# **SCOPING OPINION:**

## **Proposed Mallard Pass Solar Project**

**Case Reference: EN010127**

**18 March 2022**

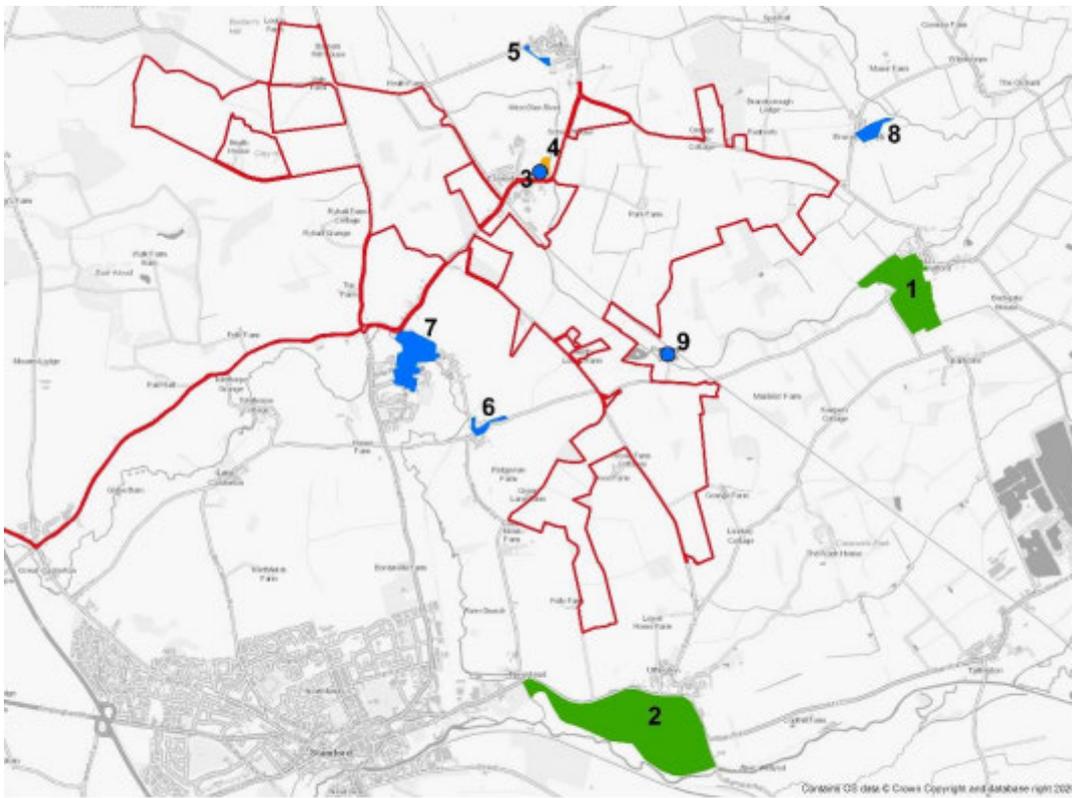
There is a concern that there is potential for impact on the setting of the GI listed Burghley House and its GII Registered Parkland.

The Burghley Estate is located on the south side of the Welland Valley. The proposed large scale solar farm is sited on the north side of the valley and appears to extend over the top and into the valley. There is strong concern that the solar farm will be in plain view.

Clearly the setting of Burghley is of high significance and landscape views into and out of the site is of considerable importance.

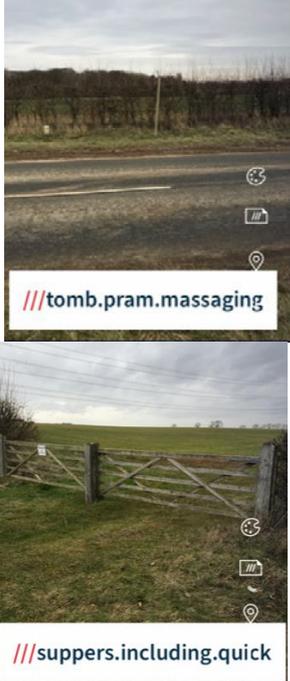
<p>5</p>	<p>This looks out onto an area of mitigation on to field 39 where there will be no panels and it is not next to a footpath.</p>	<p>Recommend moving this further up the road towards Carlby and positioned next to the footpath sign outside Grange Farm that would provide a relevant viewpoint of the panels across field 36.</p> 
<p>6</p>	<p>This is on the wrong side of the railway line with no solar PV fields visible.</p>	<p>The north side of the railway, 20 yards along the bridleway adjacent to field 35 provides long distance views of the PV panels. (This pic is a few yards too early as in a dip)</p> 
<p>7</p>	<p>This is on a footpath which leaves green lane just after it starts on Newstead Lane. The point chosen is only just into the field and the current scrub land at the field edge is so high is blocks the view across to Wood Farm. The panels are to be located on this field.</p>	<p>These 2 viewpoints on this path are far more representative of the views.</p>

8	<p>This point shows clearly the impact of the solar panels when looking across the fields as you pass gateways. Panels will be visible all along the road from Uffington to Essendine though the hedge varies in thickness and height and will afford some screening along parts of the road particularly in summer when in full leaf. This viewpoint is OK.</p>	
9	<p>This viewpoint is restricted with hedgerow which is a feature down Uffington Road. I suggest the viewpoint is taken in an open gateway.</p>	
10	<p>This viewing point is on a footpath which leaves the village of Belmesthorpe off Castle Rise. There is no visibility of the proposed solar farm which is up an incline and on the other side of a fully hedged bridleway. There is no logic for it to be included. <b>This should not be a montage view.</b></p>	No available alternative.
11	<p>This viewpoint is fine.</p>	
12	<p>This viewpoint is located on the B1176 at the point a footpath joins the road between fields 9 and 12. The viewpoint will show clearly the visual impact of the arrays when looking across the fields to Essendine, so relevant for walkers and horse riders. However, it is a low point on the road and does not necessarily give a true perspective of the panels from the</p>	<p>Also suggest these viewpoints at the Drift junction looking east to Essendine across field 9, and NW in field 2.</p>

<p>higher points of the road when travelling from Ryhall to Little Bytham by vehicle.</p> <p><b>Could be a montage option.</b></p> <p>Also suggest the following points opposite.</p>	
<p>13</p>	<p>The hedge is high and dense and so the fields where arrays will be mounted is not very visible at the particular point shown on the byway. It misrepresents the open coppices that flag both sides of the drift and the clear visibility field users will have where the arrays will be mounted. This by-way is very well used by walkers, horse riders, cyclists and a variety of other road users.</p>	<p>Alternative suggestions still adjacent to field 13. <b>Good montage point</b></p> 
<p>14</p>	<p>This is located at Barbers Hill at the most northerly point of the scheme. However, the location is on a high, flat &amp; straight piece of road which completely misrepresents the true topography of the area – the south facing slope of the field is not evident and the viewpoint does not give a true indication of the visual impact the scheme will have – this is clearly evident just a 100yds or so further south along the B1176 – see opposite</p>	<p>V slightly further south on B1176 looking down the hill and across towards Essendine. <b>A good montage option.</b></p>
